SERVICE BULLETIN

SERVICE BULLETIN	NO.: MSB-95E54-003	
	DATE: 1996-02-15	<MODEL> (EC,EXP)CARISMA <M/Y> 96-00
SUBJECT: CHANGE OF WIRING HARNESSES		
GROUP: CHASSIS ELECTRICAL	DRAFTNO.: 95-CH-007	
INFORMATION	OVERSEAS SERVICE DEPT	R. Usami R. USAMI - MANAGER QUALITY INFORMATION ANALYSIS

1. Description:

This Service Bulletin informs you of changes in the following wiring harnesses and circuits.

FRONT FOG LAMP

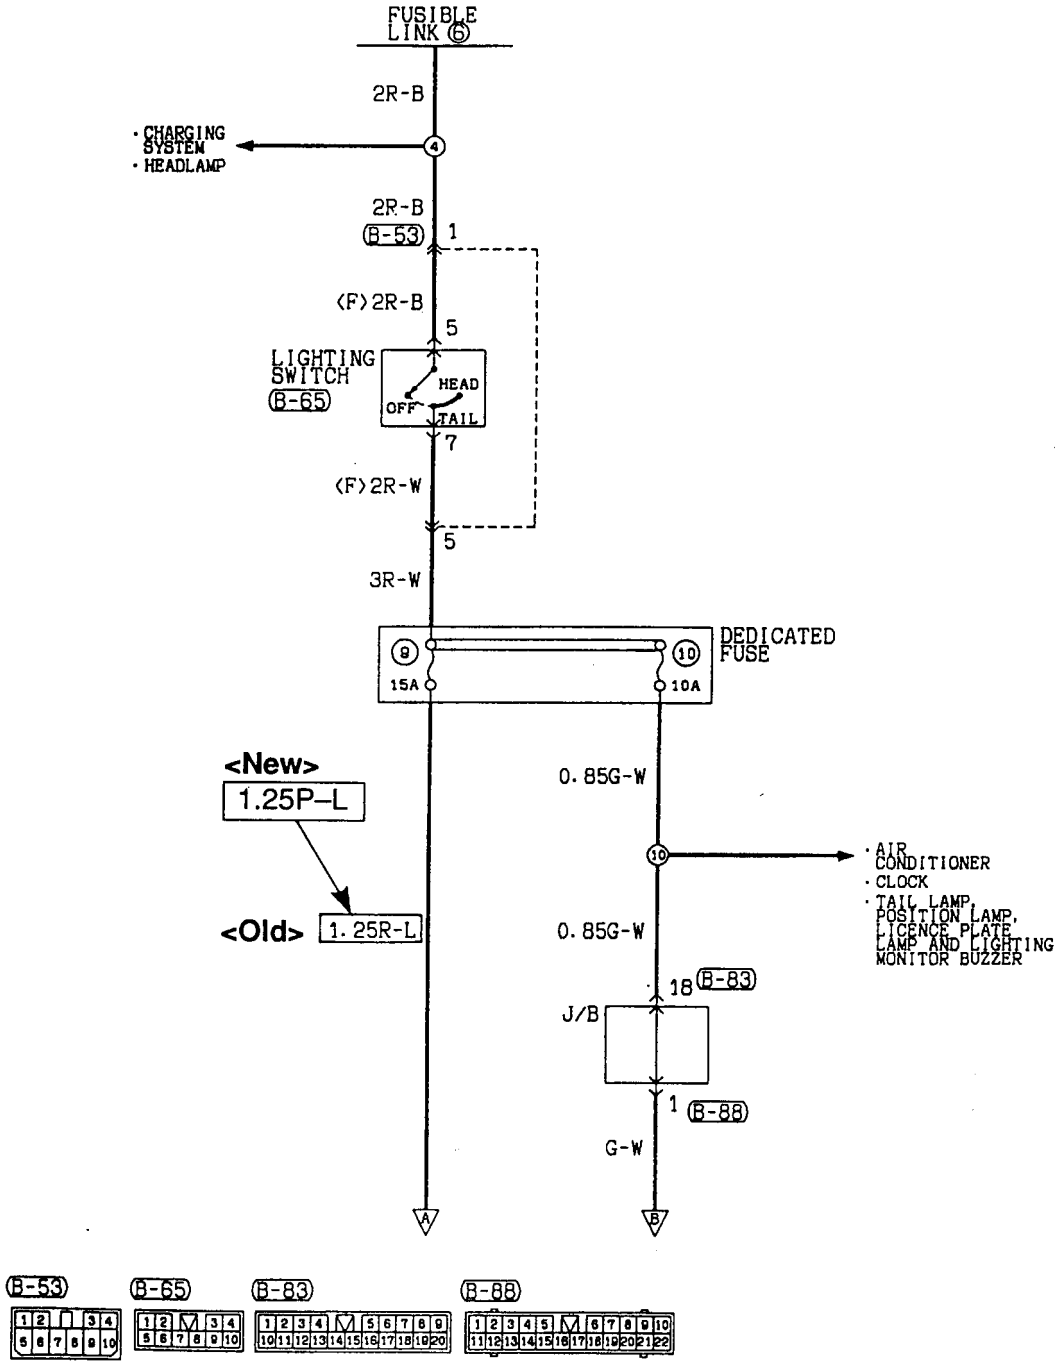
(1) Change of wire colors
- A/T
- HEADLAMP LEVELING SYSTEM
- FRONT FOG LAMP
- REAR FOG LAMP
- TURN-SIGNAL LAMP AND HAZARD WARNING LAMP
- HORN
- CENTRAL DOOR LOCKING SYSTEM
- POWER WINDOWS
- REAR WIPER AND WASHER
- HEADLAMP WASHER
- REMOTE CONTROLLED MIRROR
- ANTI-LOCK BRAKING SYSTEM (ABS)
- IMMOBILIZER SYSTEM

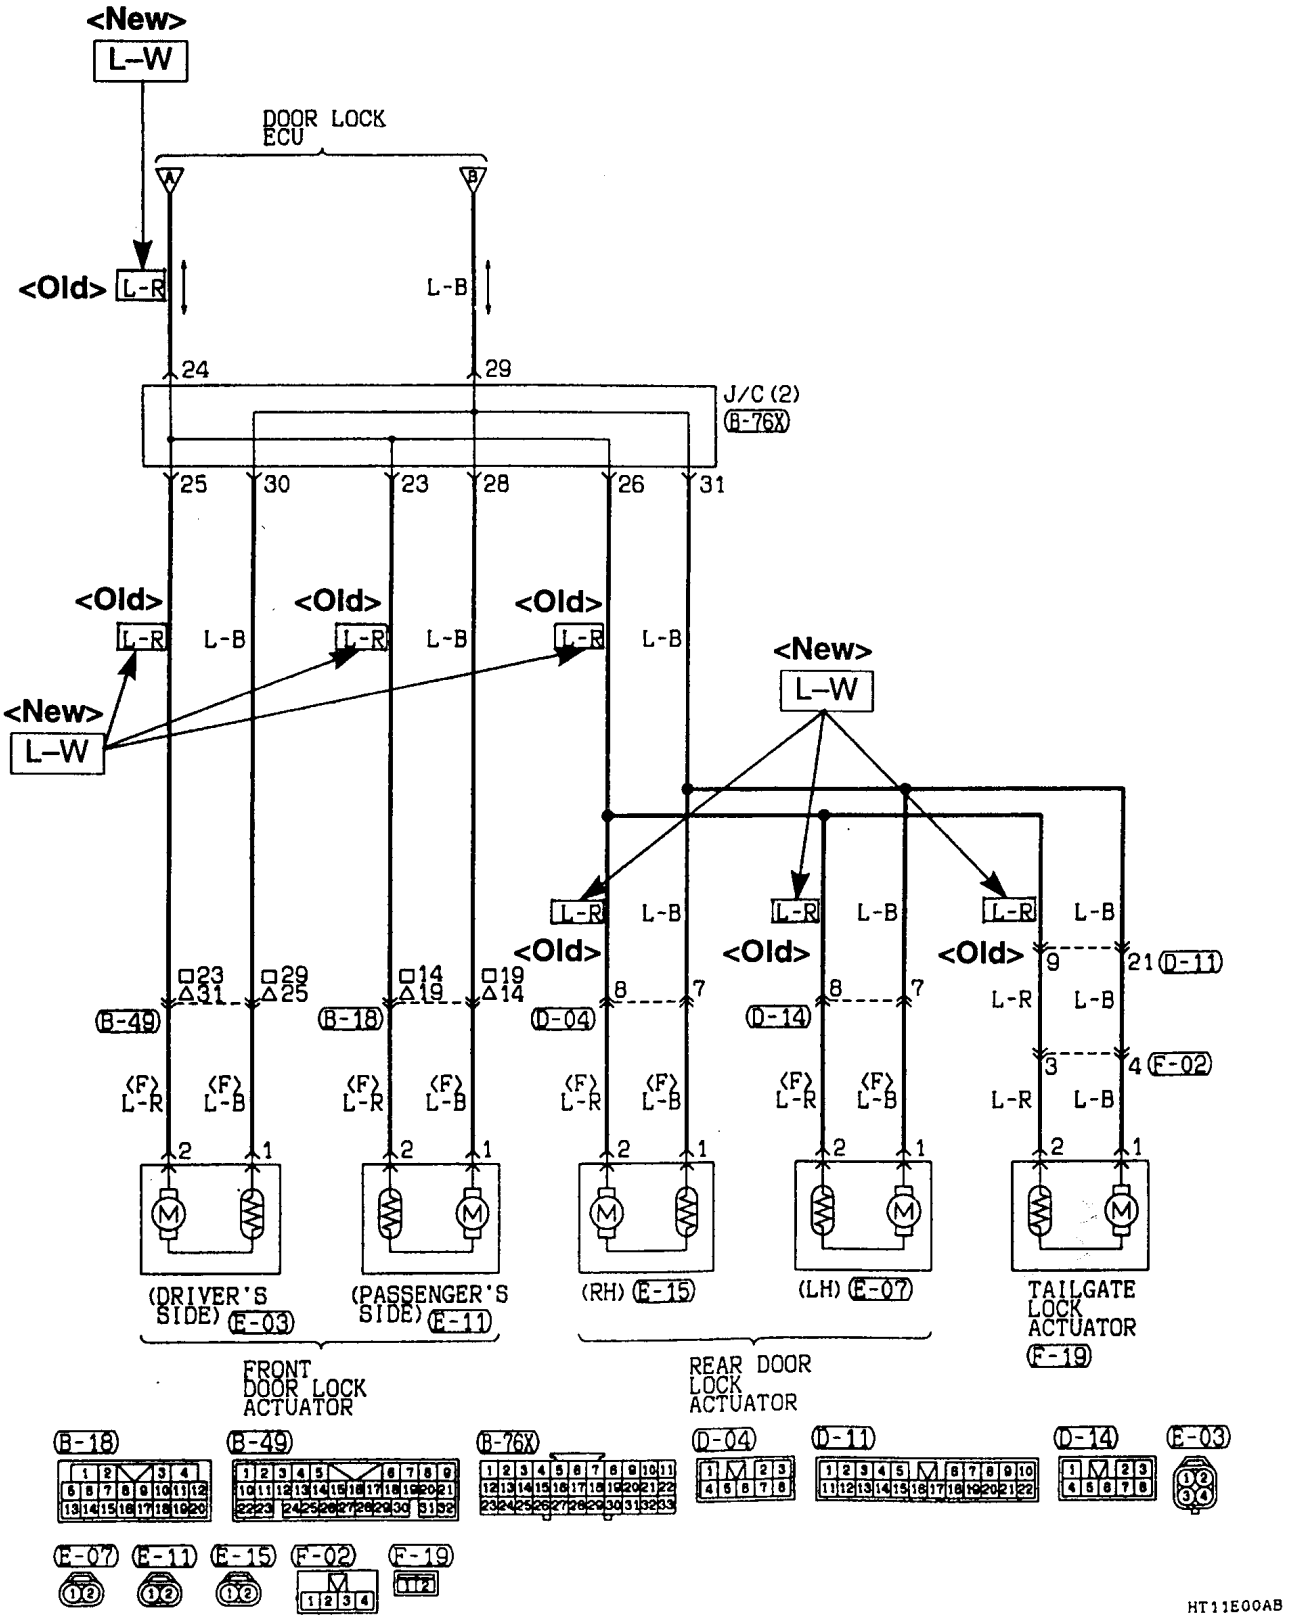
<New>
L–W
DOOR LOCK ECU
<Old> L-R
L-B
24
29
J/C (2) B-76X
25 30 23 28 26 31
<Old> <Old> <Old>
L-R L-B L-R L-B L-R L-B
<New>
L–W
<New>
L–W
L-R L-B L-R L-B L-R L-B
<Old> <Old> <Old>
□23 △31 □29 △25
□14 △19 □19 △14
8 7 9 21 D-11
B-49 B-18 D-04 D-14
3 4 F-02
(F) L-R (F) L-B
2 1
(DRIVER'S SIDE) E-03
(PASSENGER'S SIDE) E-11
(RH) E-15
(LH) E-07
TAILGATE LOCK ACTUATOR F-19
FRONT DOOR LOCK ACTUATOR
REAR DOOR LOCK ACTUATOR
B-18 B-49 B-76X D-04 D-11 D-14 E-03
E-07 E-11 E-15 F-02 F-19
HT11E00AB

POWER WINDOWS

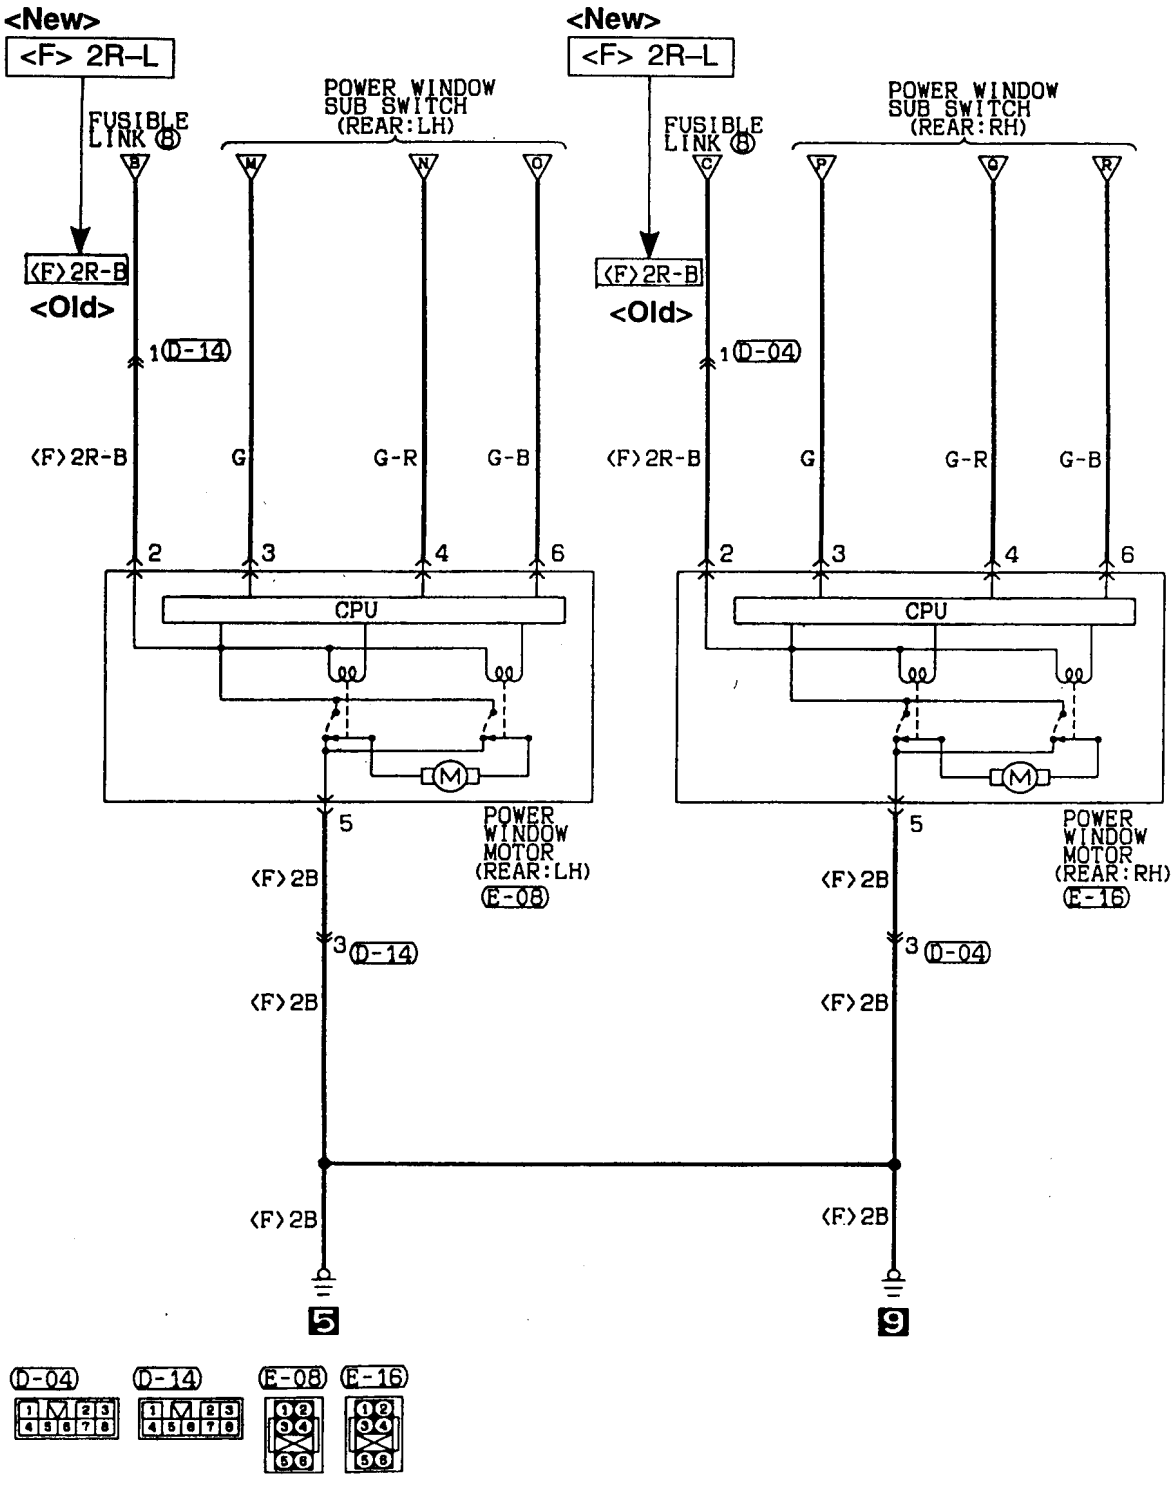
<New>
<F> 2R-L
FUSIBLE LINK ⑧
POWER WINDOW SUB SWITCH (REAR:LH)
B
W
W
O
⟨F⟩2R-B
<Old>
1 D-14
⟨F⟩2R-B
G
G-R
G-B
2
3
4
6
CPU
M
5
POWER WINDOW MOTOR (REAR:LH)
E-08
⟨F⟩2B
3 D-14
⟨F⟩2B
⟨F⟩2B
5
<New>
<F> 2R-L
FUSIBLE LINK ⑧
POWER WINDOW SUB SWITCH (REAR:RH)
C
P
Q
R
⟨F⟩2R-B
<Old>
1 D-04
⟨F⟩2R-B
G
G-R
G-B
2
3
4
6
CPU
M
5
POWER WINDOW MOTOR (REAR:RH)
E-16
⟨F⟩2B
3 D-04
⟨F⟩2B
⟨F⟩2B
9
D-04
D-14
E-08
E-16

WINDSHIELD WIPER AND WASHER

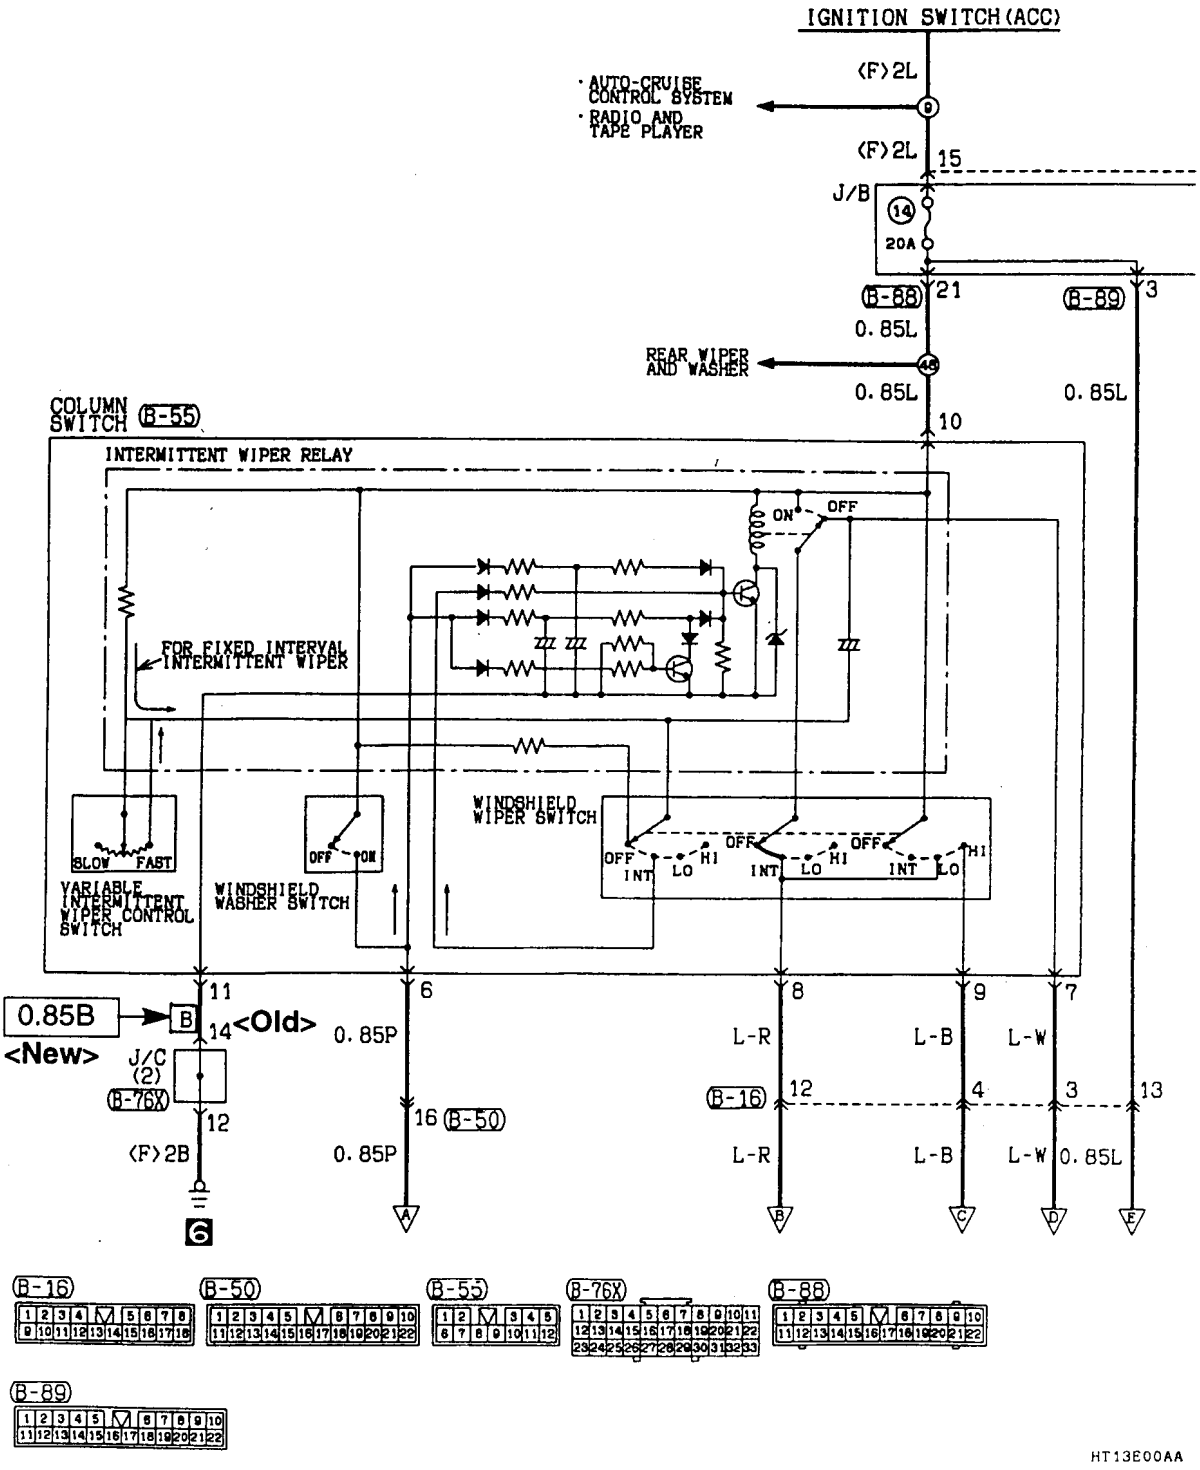
(2) Change of wire diameters and colors
- WINDSHIELD WIPER AND WASHER

ANTI-LOCK BRAKING SYSTEM (ABS)

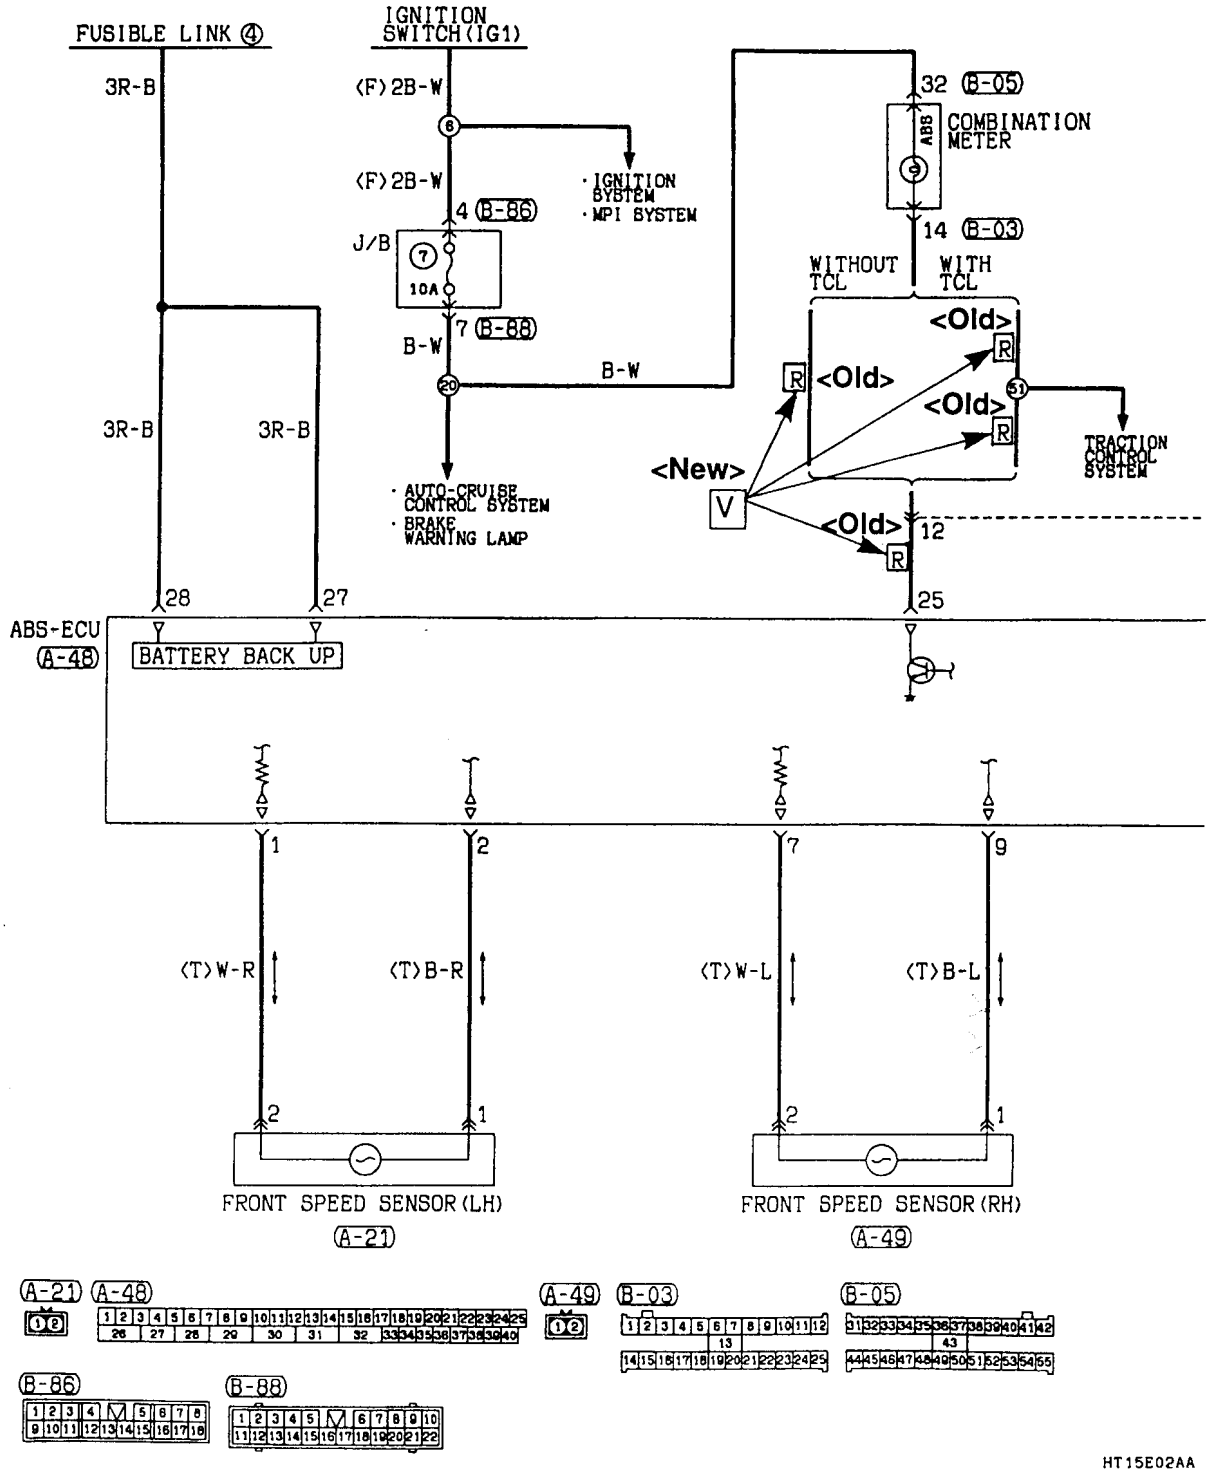
(3) Changes in circuits
- A/C CONTROL PANEL AND ECU ASSEMBLY TERMINAL NO. 18
- ABS-ECU TERMINAL NO. 14
